Memorandum to the City of Markham Committee of Adjustment

File: A/110/22

Address: 19 Grenfell Crescent – Markham, ON

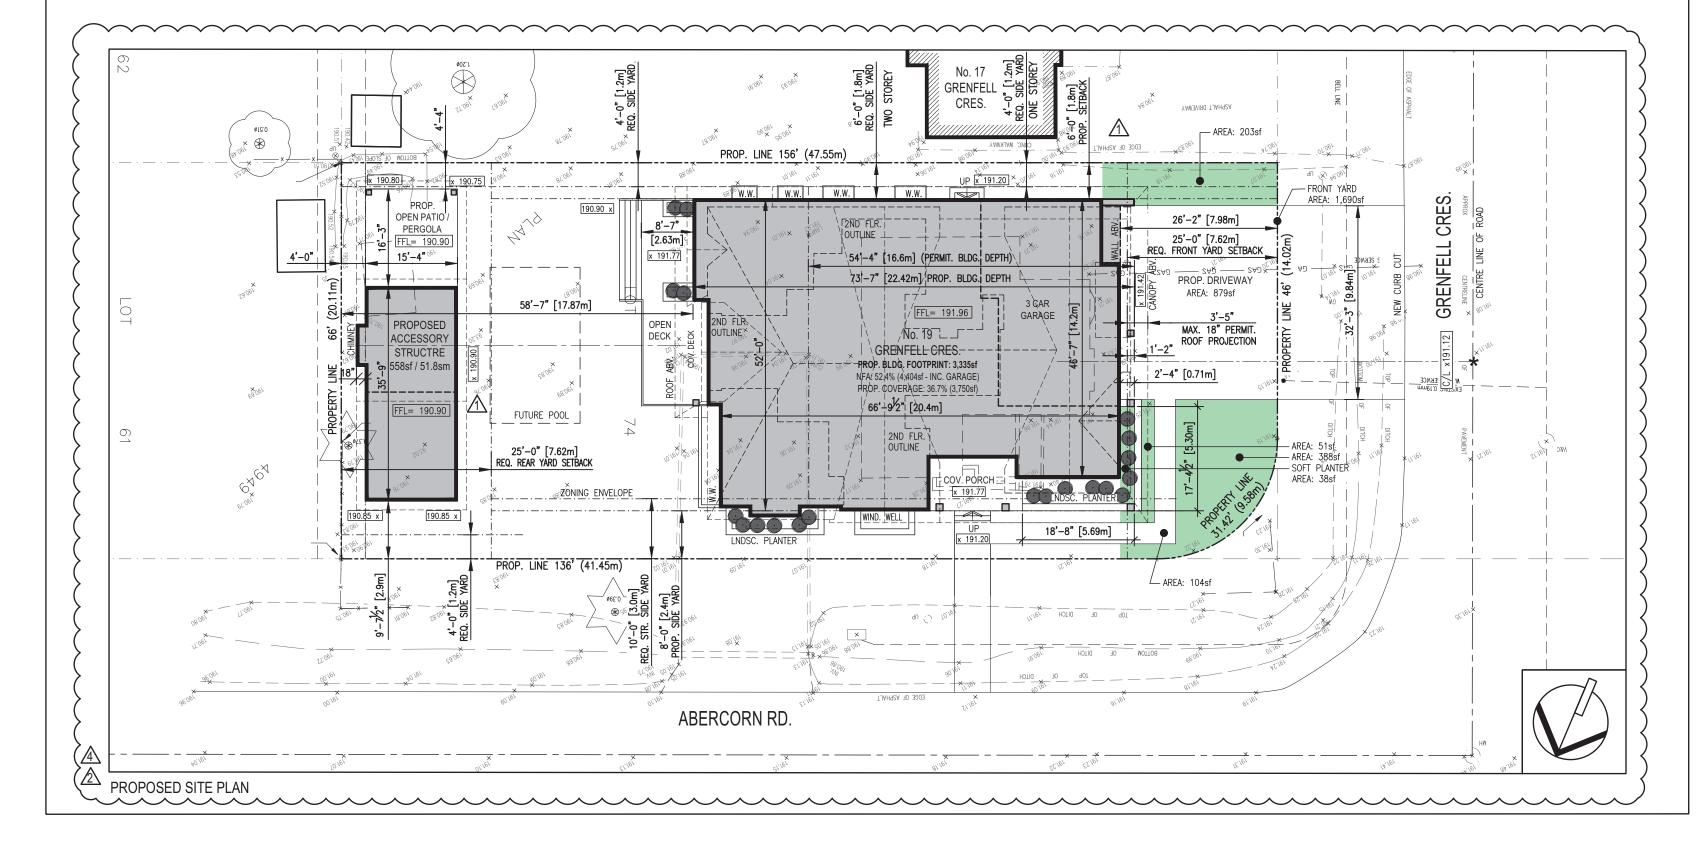
Staff have regard for tree protection and direct property owners to the City's Tree Permit process for any on-site trees, including City street trees in accordance with the City's Tree Preservation By-law. Tree Preservation staff has expressed concerns with the location of the accessory structure and pergola as it relates to encroachments into the minimum tree protection zones for those trees located on site, and recommend that the minimum tree protection zones be maintained. Planning staff note that the accessory structure is permitted by the Zoning By-law provided that it meets specific criteria, including that it does not occupy more than 10.0% of the lot area, is located in the rear yard, and also noting the maximum lot coverage request of 42.20% includes and is partially attributable to the proposed accessory building.
